VILLAGE DESIGN REVIEW COMMITTEE DESIGN STANDARDS REVIEW

SUBJECT PROPERTY: 6660 old 28th street

APPLICANT: Thomas Kuiper of Kuiper & Kraemer

VILLAGE DESIGN REVIEW COMMITTEE COMMENTS:

1. Dumpster Enclosure Plan

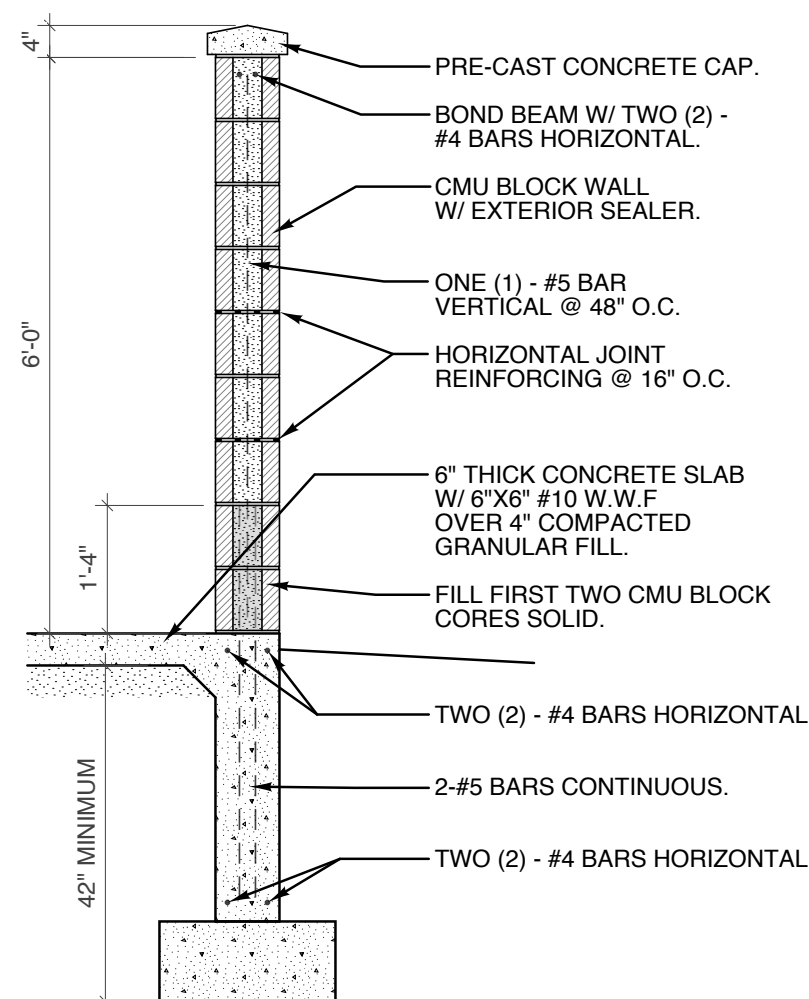
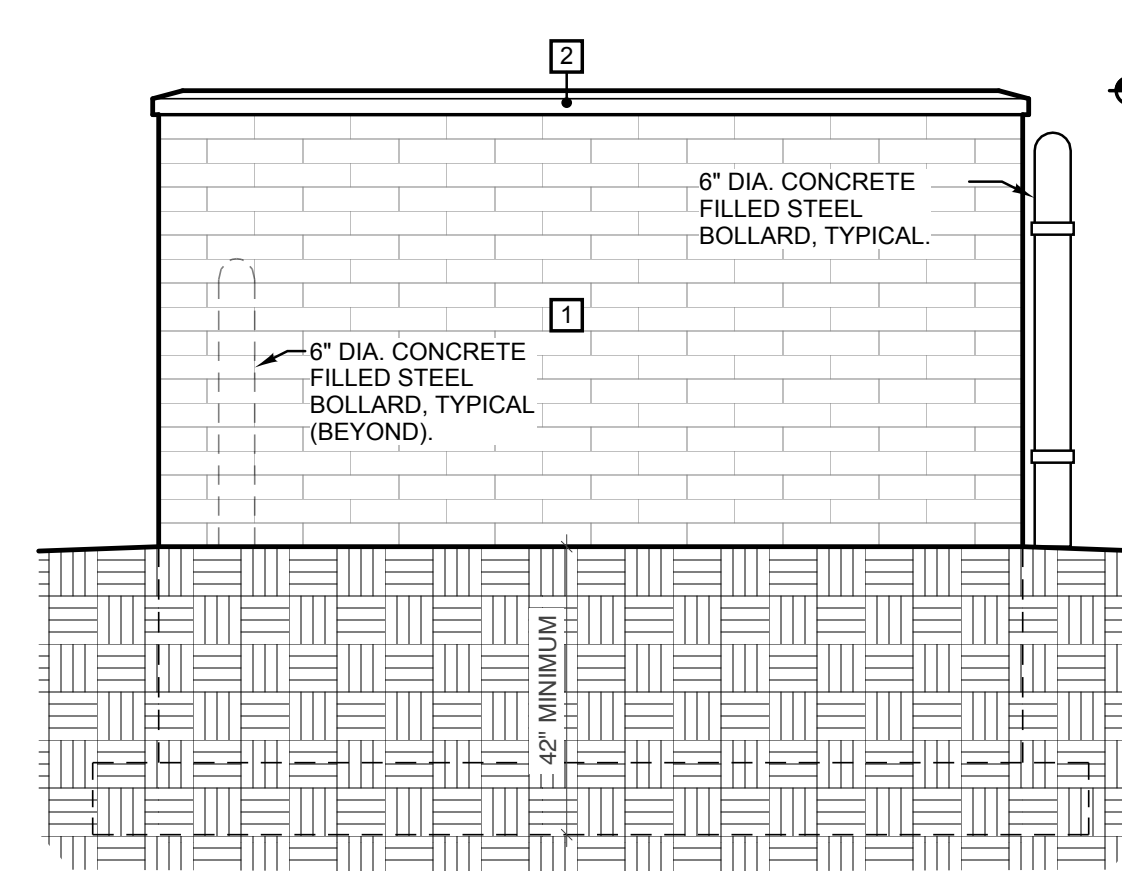
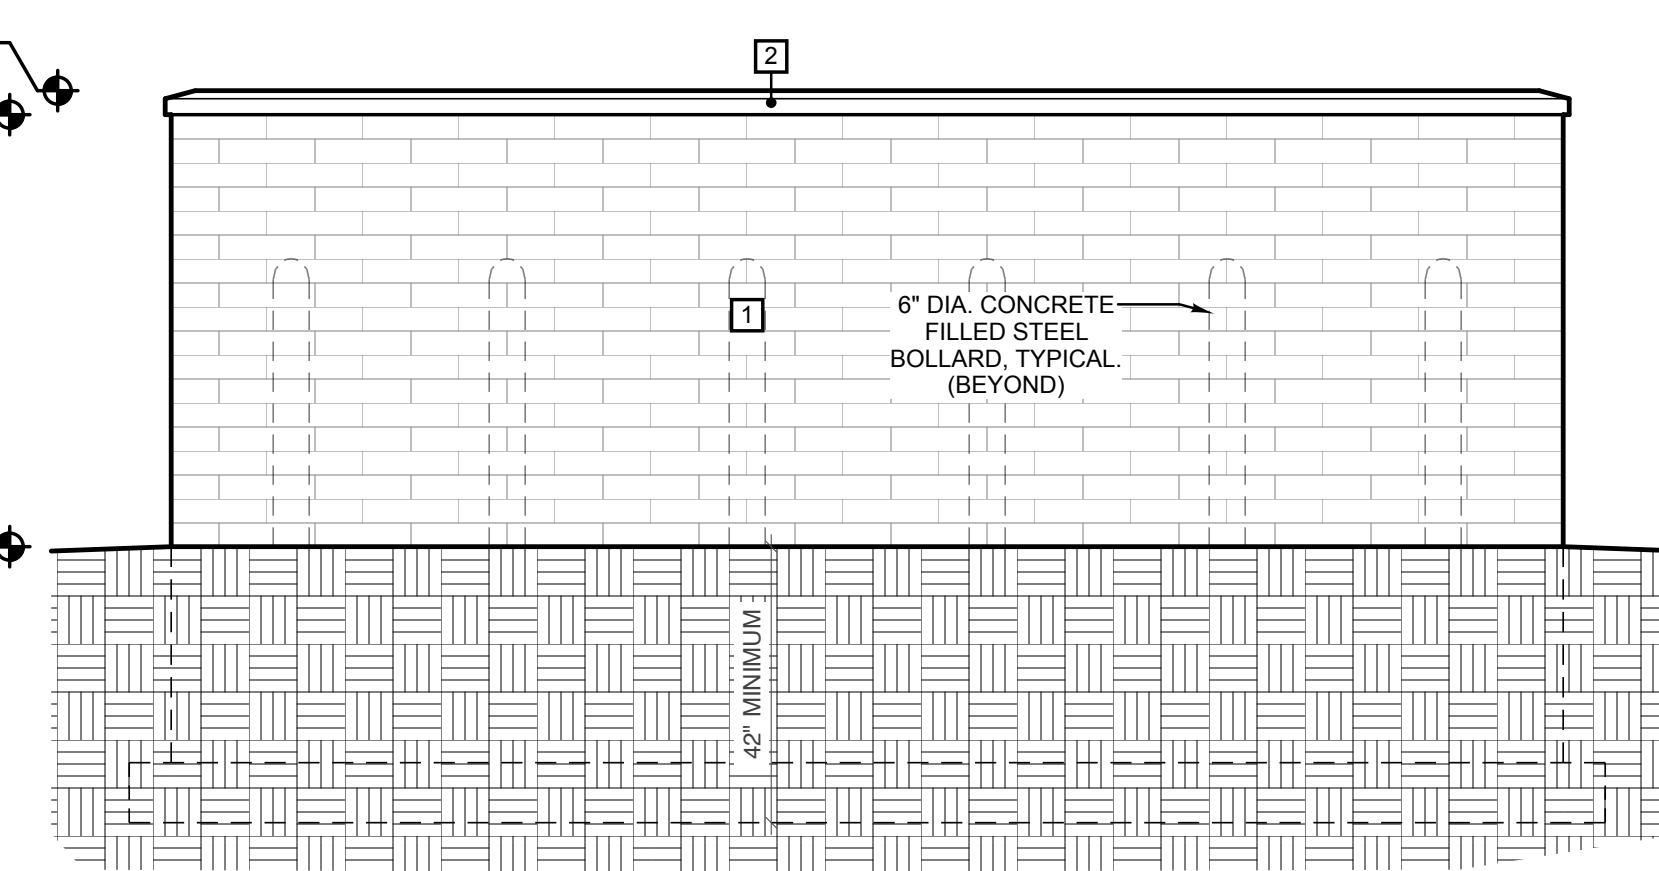
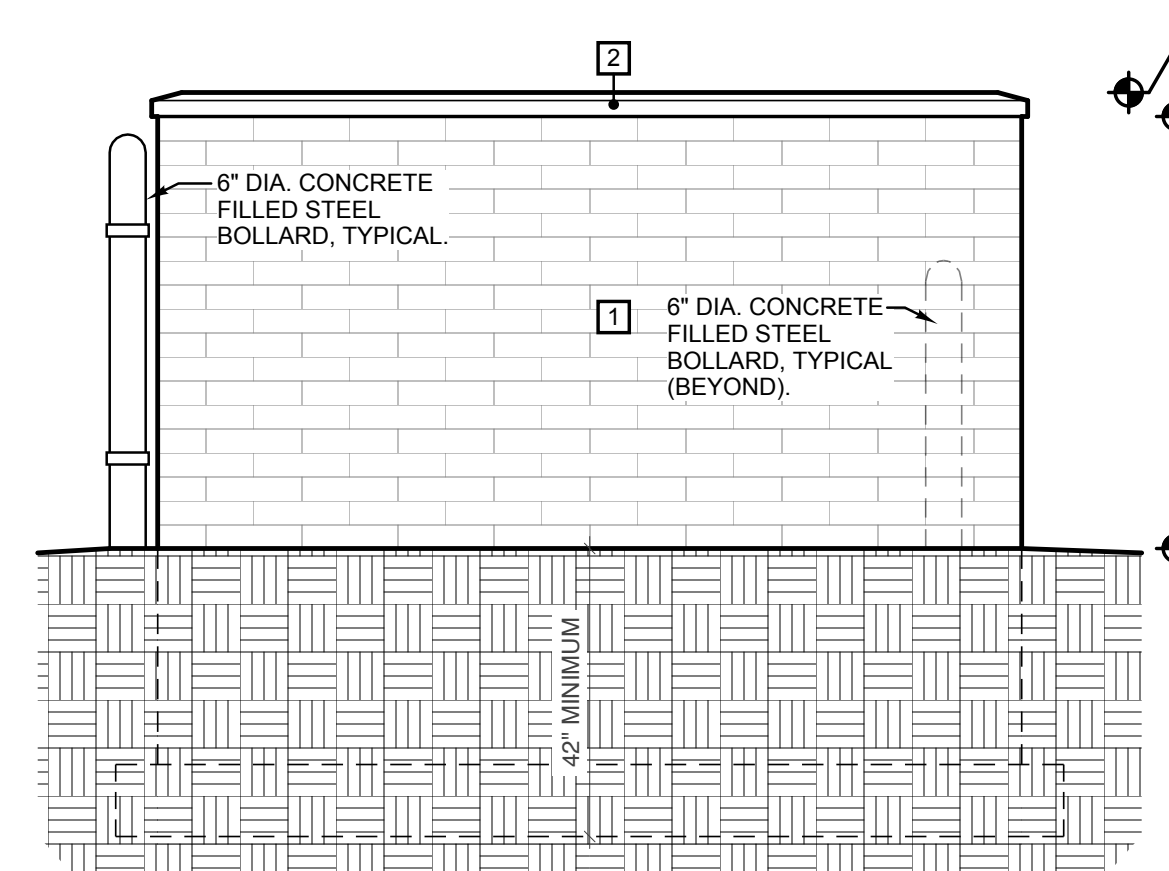
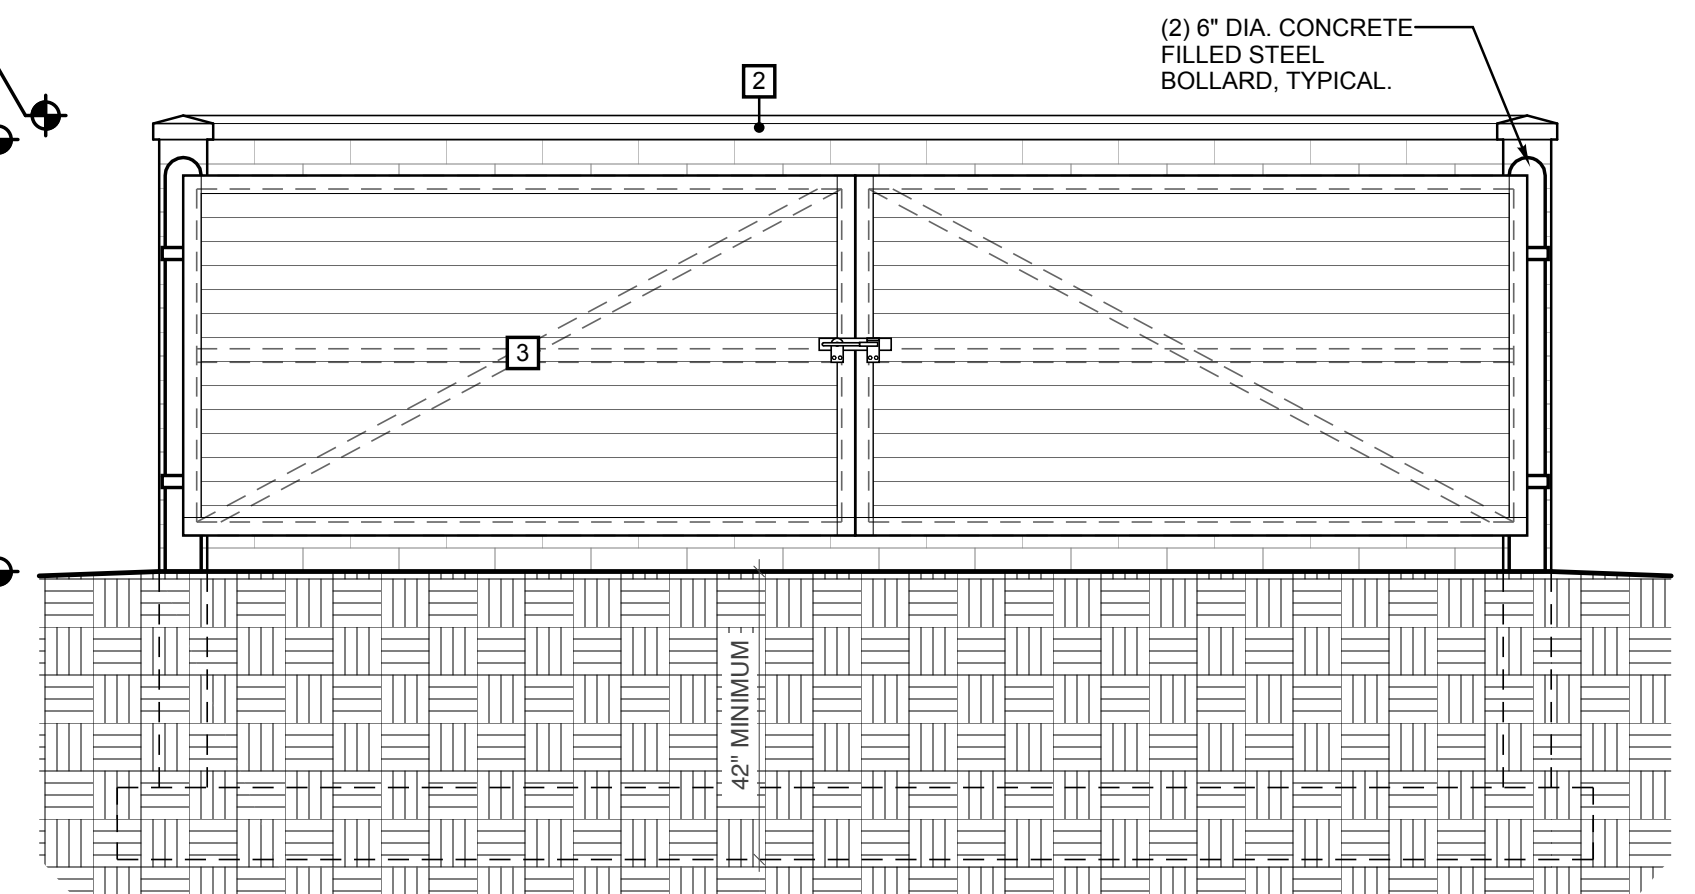
15. Chain link fence shall be prohibited.	No chain link fence is proposed. The standard is met.
16. Dumpsters shall be located in the rear yard or side yard and must be screened. These facilities shall be enclosed with a solid fence or wall six (6) feet high with solid doors having sufficient truck access for dumpster service.	The dumpster is in the rear (south) side behind the parking lot. A twelve (12) foot by nineteen (19) foot brick dumpster enclosure with solid doors is on the plans. The door is Faux Wood Siding over Steel Frame. The height of the enclosure is six (6) feet. The standard is met.
